CALVERT CLIFFS
NUCLEAR POWER PLANT

SUBJECT: Calvert Cliffs Nuclear Power Plant
Unit Nos. 1 & 2; Docket Nos. 50-317 & 50-318
Supplement to the License Amendment Request: Transition from Westinghouse
Nuclear Fuel to AREVA Nuclear Fuel

NON-PROPRIETARY SUPPLEMENT TO LICENSE AMENDMENT REQUEST: TRANSITION TO AREVA NUCLEAR FUEL

Figure 2-1, Loss-of-Coolant Flow Analysis at Hot Full Power

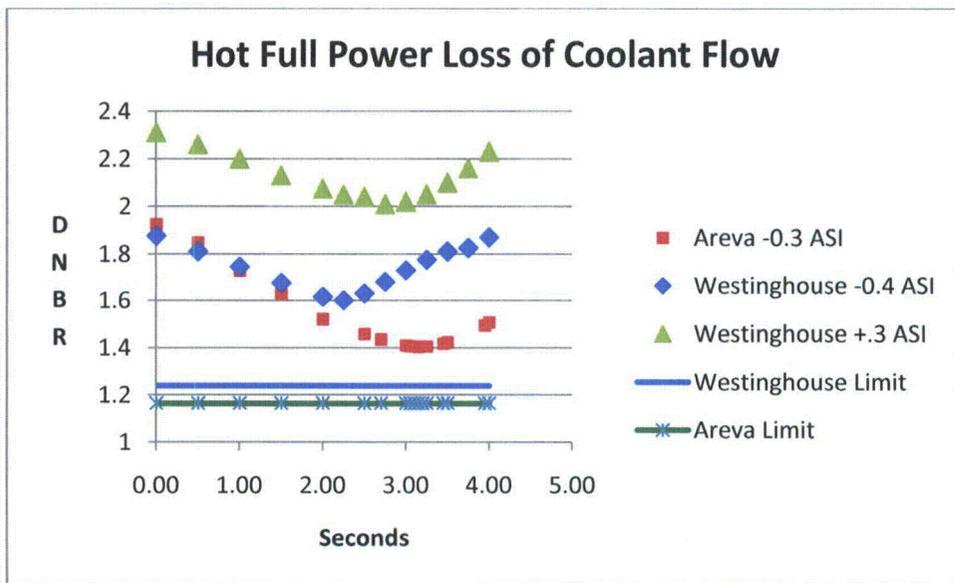
- d. *At different exposure levels, compare the calculated AOO and accident overpower required to achieve the Westinghouse and AREVA cladding strain SAFDL and compare to the predicted overpower for all Chapter 15 AOO and accidents.*
- e. *NUREG-0800, SRP-4.2 requires that the number of failed fuel rods not be under predicted. How do the transition core reload methods quantify the number of Westinghouse fuel rods which violate any SAFDLs during any accident conditions?*
- f. *For CCNPP-2 Cycle 19, provide a plot of minimum DNBR versus time (current UFSAR analysis (TURBO) versus new AREVA analysis (CE14 HTP)) for several AOO and accident analyses.*

Also, the 9% margin was verified for the limiting cases of transient events that result in power redistribution, including MSLB, CEA Withdrawal, and CEA Drop.
- c. Response to be provided separately.
- d. Response to be provided separately.
- e. Response to be provided separately.
- f. The requested plots are shown below (Figures 2-1 through 2-4). Note that for the current Calvert Cliffs UFSAR analysis, the core is assumed to be loaded with Turbo fuel only. The AREVA analyses reflected in the Figures below assume a mixed core of AREVA and Westinghouse fuel (except for the Excess Load at hot full power figure which assumes a full core of AREVA fuel).

Figure 5-1, Graphical Depiction of Transient Shift

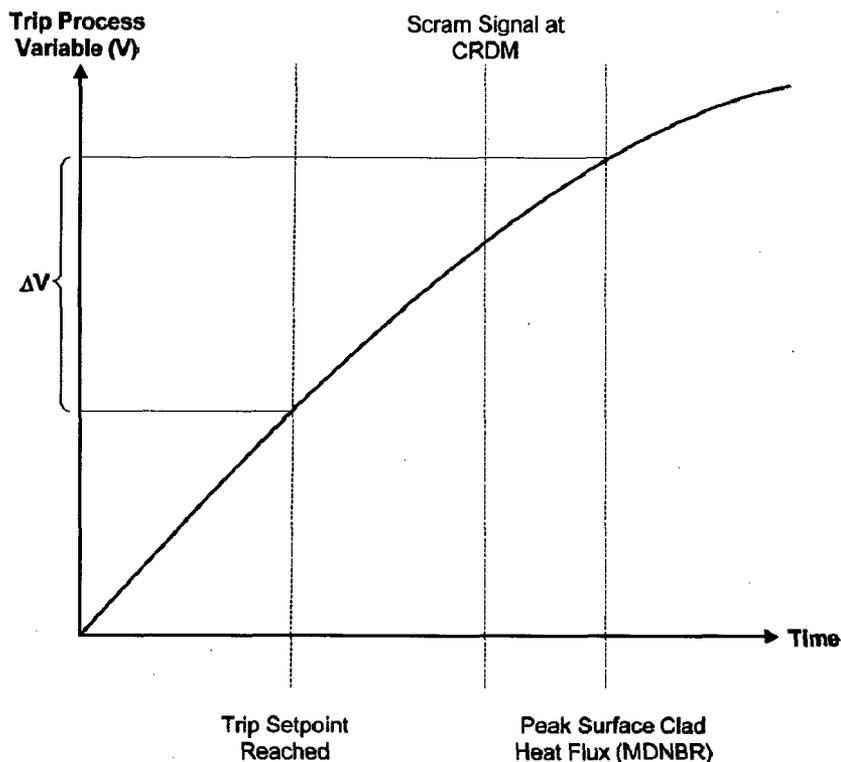
Provide a detailed summary describing the process for transient-specific verification of analog instrument setpoints, delays, and uncertainties, and the evaluation of the resultant impact on transient and accident analysis results.

Figure 5-1, shown below, graphically depicts the concept of a transient shift. Consider a time-dependent trace of an uncompensated trip input parameter, V, near the point where the setpoint of that trip is reached in a transient. This process parameter continues to change between the point at which the setpoint is reached, and the point of peak DNBR or fuel centerline melt challenge. If dynamic compensation on the signal is not used to reduce the overshoot ΔV , then the overshoot bias ΔV must be accommodated in the setpoint calculation. This adjustment is performed in the Combustion Engineering statistical setpoint analysis calculation.

Figure 13-1, Moderator Reactivity vs Moderator Density

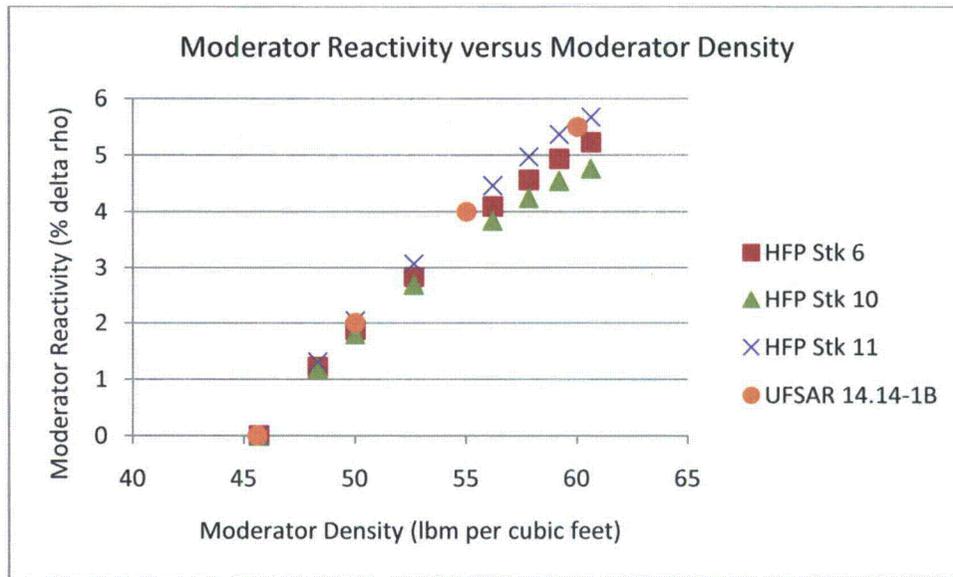
Discuss differences in the moderator reactivity versus moderator density curve used in the current S-RELAP5 calculations relative to the current UFSAR AOR. Include a discussion of the effects of stuck rod core location and how cycle-specific differences will be addressed for future reloads.

The moderator cooldown curve and the trip curve used in the current Calvert Cliffs UFSAR AOR are calculated assuming a stuck CEA, which reduces the scram worth and increases the magnitude of moderator reactivity feedbacks. The curves shown in Figure 13-1 assume an end of cycle-hot full power moderator temperature coefficient of $-3.3 \times 10^{-4} \Delta\rho/^\circ\text{F}$. Calvert Cliffs UFSAR Figures 14.14-1A and 14.14-1B display the Unit 1 and Unit 2 moderator density vs. reactivity curves. The curves shown in the Calvert Cliffs UFSAR figures correlate to the worst stuck CEA; the reactivity inserted with lesser worth CEAs tends to flatten at increased density.

For the AREVA analysis the worst stuck CEA location in PRISM has a significant impact on the moderator density vs. reactivity results. The end of cycle worst stuck CEA in the Unit 2 Cycle19 evaluation is located near the center of the core. If the stuck CEA in the PRISM input deck is changed to a peripheral Shutdown Bank A location, the moderator density vs. reactivity results closely match the UFSAR Figure 14.14-1B.

Figure 20-1, Axial Power Shape for Excess Load Event

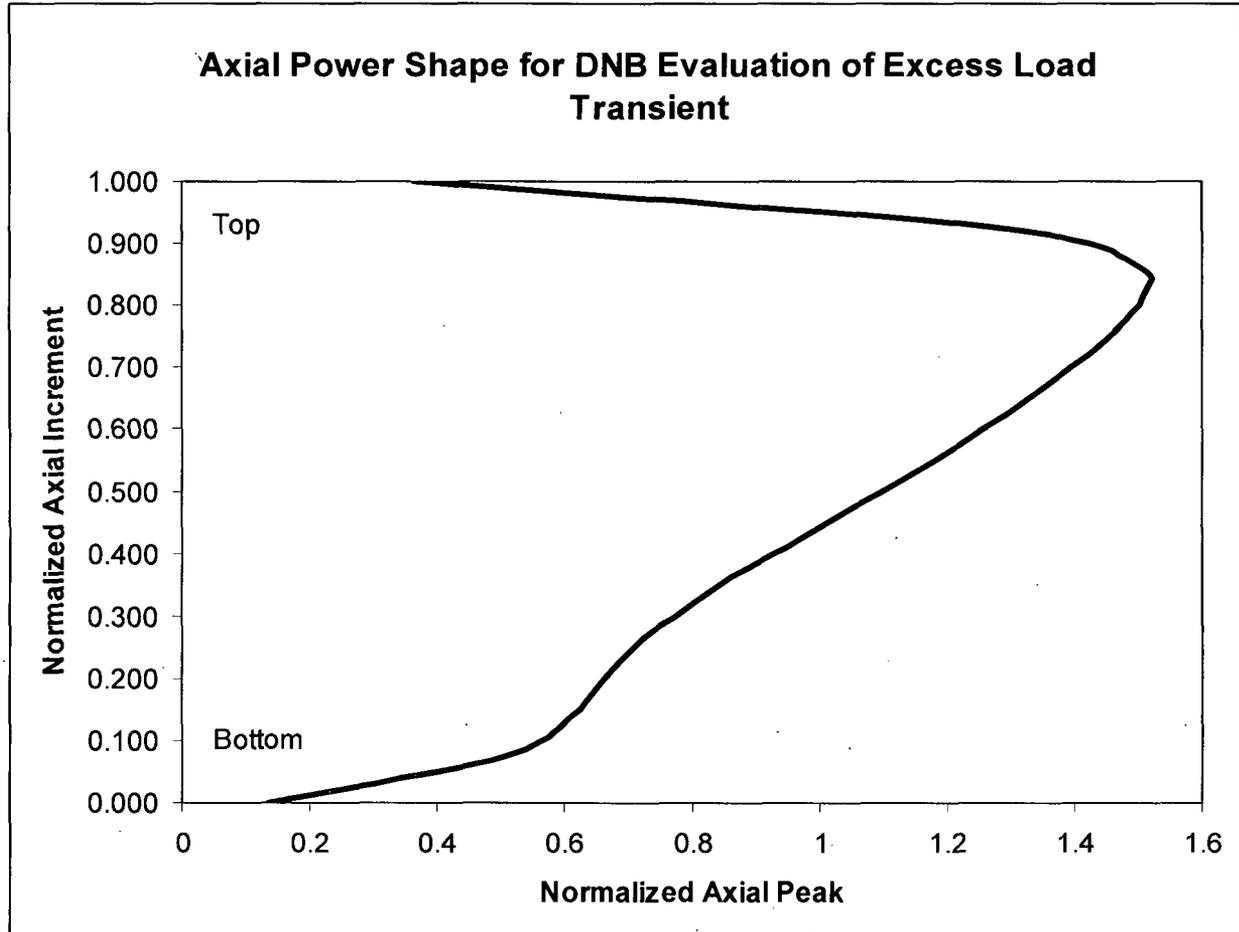
Please provide a plot of the AXPDS (current UFSAR AOR versus new analysis) used in all of the lower power AOO and accident calculations. Discuss any significant differences.

The current analysis determines linear heat rate and DNB at intermediate power levels, and the axial shapes are those allowed by the COLR figures. The AREVA analysis is performed at hot zero power. The analysis includes a “hot spot” calculation to determine fuel centerline temperature. The power (F_q) used in the hot spot calculation is calculated in PRISM. The limiting axial shape described in Figure 20-1 is used in the DNB analysis.

The excess load analysis is performed at hot zero power conditions. The AREVA analysis includes a "hot spot" calculation to determine linear heat rate. The power (F_q) used in the hot spot calculation is calculated in PRISM. The limiting axial shape described in Figure 20-1 is used in the DNB analysis.

Figure 20-1 shows the limiting design axial power profile that was used in the XCOBRA-IIIC calculation for all power levels. The limiting design axial power profile corresponds to an ASI of -0.30 asiu which is the local power density limiting safety system setting ASI limit at 90% rated thermal power. The limiting design axial power profile provides conservative minimum DNBR results compared to the cycle-specific limiting axial profile.
